**PLAN COMMISSION PC #18-010**  
**Arlington Downs Phase 2**  
**3400 W. Euclid Ave.**  
**PUD Amendment, Pre/Final Plat of Subdivision, LUV**  
**Round 2 (revised)**

## REVIEW ROUND 2

Project: 3400 W. Euclid Ave.  
Arlington Downs PUD Amendment

Case Number: PC 18-010

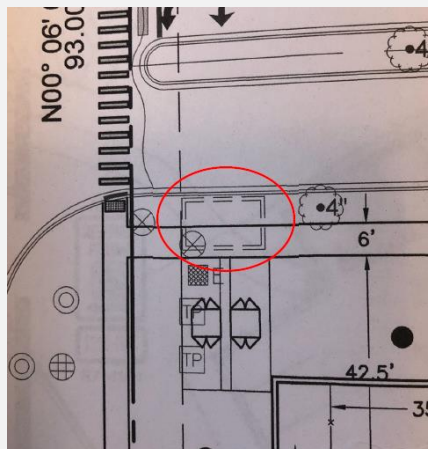
56. The response to comment #22 is not acceptable as outlined below:
- The response to #22a did not address the lack of clarity within the table. Within the Lot Coverage table, "Zone 2B" should read "Zone 2B/Lot 16" since the data within includes both of those properties. The dwelling unit value in this zone should be 360 and not 180 since 360 units are proposed on 2B/Lot 16.

- Please cross-check all data within the tables on sheet A010. The square footage of retail/restaurant buildings A, B, C, and D as shown on the site plan equates to 30,300 square feet, however, the data within the table shows it as "General Retail, 29,800 sq. ft.", then there is a breakout showing 19,995 square feet for restaurants and the building footprint is listed at 29,900 sq. ft. The data in this table should clearly indicate the overall square footage of the retail/restaurant buildings and the estimated restaurant square footage out of the total.

- The civil plans, architectural plans, floor plans, and landscape plans are still uncoordinated. The parking in Zone D is shown as 474 stalls on the architectural plans and 479 spaces on the civil plans and the locations of parking stalls don't match. The locations of bicycle parking racks are inconsistent across all plans. The central plaza area on the landscape plan is different compared to all other plans. There are areas on sheet A010 that are proposed as grass on the landscape plan but shown with a concrete pattern on sheet A010. The trash enclosures in Zone D appear to have solid walls on the civil plans but a note on sheet A010 calls for these enclosures to be constructed of wood. The refuse collection area for ADR-II is shown in different configurations on the civil plans, architectural site plan, and floor plans. To reiterate, please make sure all plans are consistent.

## Landscape Details

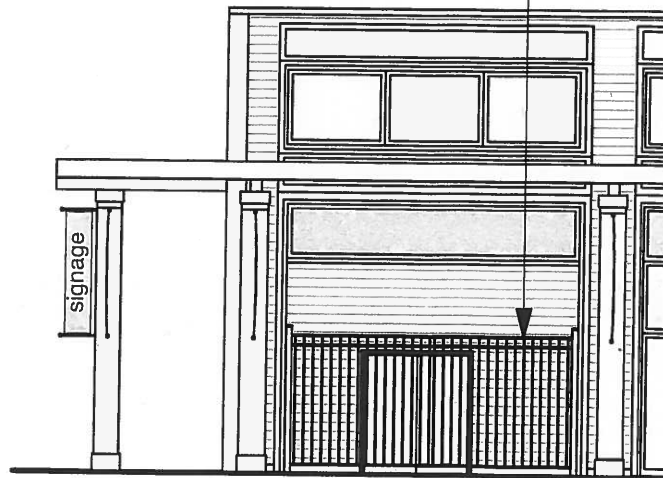
- 4) Must provide screening for service areas/drive aisles along Euclid and Rohlwing Road. The service area south of the parking garage must be fully screened and consist of walls and landscaping. Please identify how the refuse will be screened for retail 'A' and retail 'B'.

**Per the design guidelines trash, roof top mechanical units and utility areas are to be architecturally integrated with the building and not to be visible from the surrounding residential or street views.**

- 8) Full screening is required to enclose the trash corrals, loading areas, and utility/mechanical areas with a masonry wall or landscaping or a combination. There is mechanical equipment north of the hotel along Rohlwing Road. The equipment should be located away from the road and must be fully screened. Explore options for relocating the equipment.

**The existing mechanical equipment north of the hotel must be fully screened with landscaping. Per the design guidelines trash, roof top mechanical units and utility areas are to be architecturally integrated with the building and not to be visible from the surrounding residential or street views. Please indicate how the trash area near the parking garage will be screened.**
